Access Compliance Report

Public Rights-of-Way

(Curb Ramps)

Intersection ID: 10033360	Main Street: OLD_ARDREY_KELL_RD	Cross Street: N/A	Location: NE
ADA ID: C7B810ED34EC	Ramp Type: BlendTrans1	Initial Pass/Fail: Fail	Overall Compliance: No
			Severity Score: 1.25

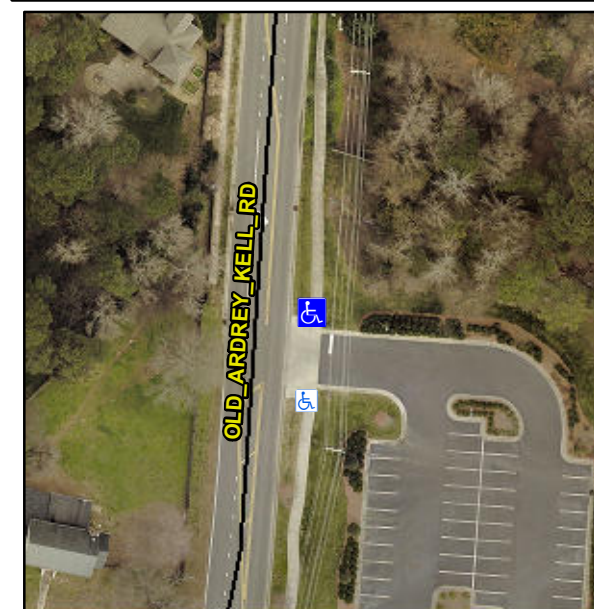
Codes/Mitigation Info/Possible Solution	Field Measurements/Component Compliance
---	---

Compliance	Description	Data	Compliance	Description	Data
N/A	Ramp Length (in)	56.0	Yes	BlendTrans Slope (%)	3.1
Yes	Ramp Width (in)	48.0	No	BlendTrans XSlope (%)	2.7
N/A	Flare Type LT	N/A	N/A	Flare Type RT	N/A
N/A	Flare Slope LT (%)	N/A	N/A	Flare Slope RT (%)	N/A
N/A	Flare Traversable LT?	N/A	N/A	Flare Traversable RT?	N/A
N/A	Landing Length (in)	N/A	N/A	DWS Provided?	N/A
N/A	Landing Width (in)	N/A	N/A	DWS Contrast?	N/A
N/A	Landing Slope (%)	N/A	N/A	DWS Length (in)	N/A
N/A	Landing X Slope (%)	N/A	N/A	DWS Full Width?	N/A
N/A	Landing Curb? (Y/N)	N/A	N/A	DWS Offset (in)	N/A
N/A	Shared Landing?	N/A			
N/A	Gutter Ponding?	N/A	N/A	Gutter Slope (%)	N/A
N/A	Gutter Lip Ht (in)	N/A	N/A	Gutter X Slope (%)	N/A
N/A	Painted X Walk1?	No	N/A	Painted X Walk2?	N/A
	X Walk 1 Direction	To S		X Walk 2 Direction	N/A
	X Walk 1 Width (in)	N/A		X Walk 2 Width (in)	N/A
	X Walk 1 Slope (%)	0.4		X Walk 2 Slope (%)	N/A
	X Walk 1 X Slope (%)	0.8		X Walk 2 X Slope (%)	N/A

N/A	Ramp inside XWalk1?	N/A	N/A	Ramp inside XWalk2?	N/A
	Road Slope (%)	0.8		Clear Space?	N/A
	Road X Slope (%)	0.4	N/A	Clear Space to XWalk (in)	N/A
N/A	Any Obstructions?	N/A	N/A	Storm Grate/Utility Hazard?	N/A
	Obstruction Type			Storm Grate/Utility Type	
		N/A			N/A
			Yes	Surface Condition? (G/P)	Good
			N/A	Curb Slope (%)	N/A

Remove & Replace Curb Ramp With Two New Directional Ramps or Equivalent.

R304.5.3
